PLAN REVIEW SHEET

2015-013

Meeting Street Homes & Communities

Waiting Pad Detail

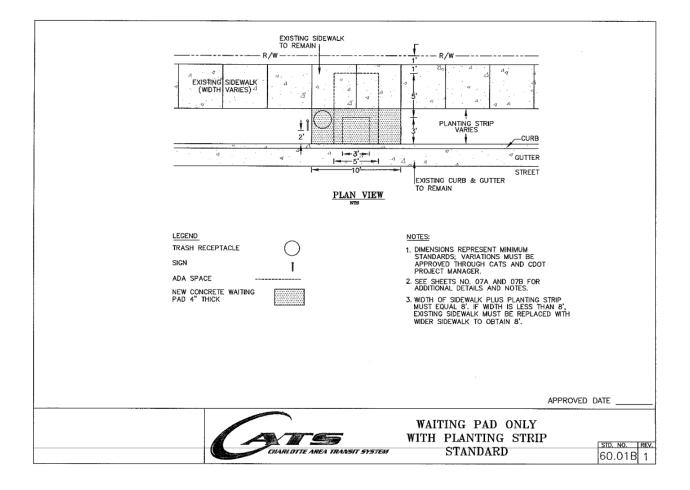
The Petitioner is requested to provide and construct a concrete pad for the existing bus stop on Kenilworth Avenue. Below is an image of the standard detail (60.01B) for the requested concrete pad. The site plan may either show the conceptual location of the improved bus stop on Kenilworth Avenue, or alternatively, include a development note to locate the bus stop pad during the urban review process.
